TOWNSITE OF SEMMES SUBDIVISION, BLOCK 1,
RESUBDIVISION OF AND ADDITION TO LOTS 20, 21,
22, AND A PORTION OF LOTS 23 AND 24

APPLICATION NUMBER 1 DATE April 17, 2008

DETAIL SITE PLAN

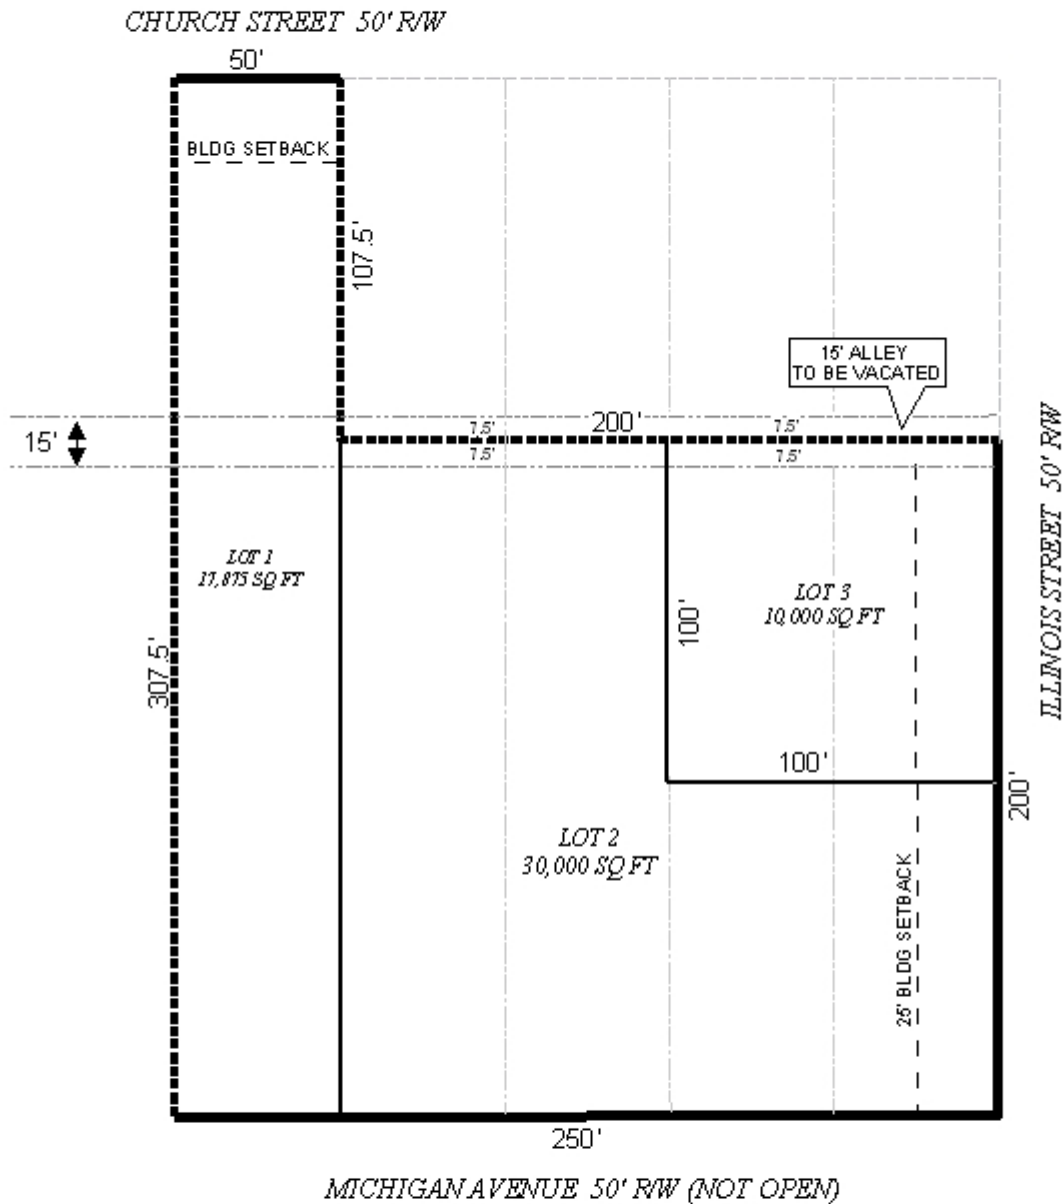
Lot 3 would front on Illinois Street which has adequate right-of-way, as does Church Street; therefore, no dedication would be required. A 25' minimum building setback line is indicated along Illinois Street and Church Street, and this should also be indicated on the final plat. As a means of access management, Lot 1 should be limited to one curb cut to Church Street, and Lots 2 and 3 should be limited to one curb cut each to Illinois Street, with the size, design, and location of all curb cuts to be approved by County Engineering and conform to AASHTO standards.

Each lot is labeled on the plat with its size in square feet. This should also be depicted on the final plat, or a table should be furnished providing the same information.

The plat indicates a 15'-wide public alley between the current Lots 5 and 20, and at the North end of the current Lots 21 and 22. A portion of the alley along the North or proposed lot 3 is indicated on the County Tax maps as having been vacated and now being a part of Tax Parcel R022406230002030.009 (proposed Lot 3). A copy of the recorded Petition for Vacation of this alley executed in 1994 was submitted with the application; however, the remainder of the alley is still indicated as being public on County tax plats. Since the alley still separates Lots 5 and 20, and is proposed to be incorporated into proposed Lots 1 and 2, the Vacation process should be completed prior to the signing and recording of the final plat, or evidence should be provided to verify that the process was completed and not properly documented on County Tax and Engineering plats. If only a portion of the alley is vacated, all lots should be denied access to the remaining substandard portion of the alley.

Lot 1 would exceed the maximum depth-to-width ratio of the Subdivision Regulations. However, since the current Lot 20 has no frontage on an open public right-of-way, combining it with the current Lot 5 to create the proposed Lot 1 would then afford access to Church Street. Also, deep lots are not uncommon of the area. A waiver of Section V.D.3. of the Subdivision Regulations would be in order.

- 1) illustration of the 25' minimum building setback line along the Illinois Street and Church Street frontages;
- 2) placement of a note on the final plat stating that Lot 1 is limited to one curb cut to Church Street, and Lots 2 and 3 are limited to one curb cut each to Illinois Street, with the size, design, and location of all curb cuts to be approved by County Engineering and conform to AASHTO standards;

- 3) placement of a note on the final plat stating that Lots 1 and 2 are denied access to Michigan Avenue until such time it is constructed to County standards, and if constructed, Lot 1 is limited to one curb cut, and Lot 2 is limited to two curb cuts to Michigan Avenue, with the size, design and location of all curb cuts to be approved by County Engineering and conform to AASHTO standards;

- 4) labeling of each lot with its size in square feet and acres, or the provision of a table on the final plat furnishing the same information;
- 5) completion of the alley Vacation process prior to the signing and recording of the final plat, or submission of documentation verifying such was done and not properly documented on County Tax and Engineering plats;

- 6) if only a portion of the alley is vacated, placement of a note on the final plat stating access to the remaining substandard portions of the alley is denied;
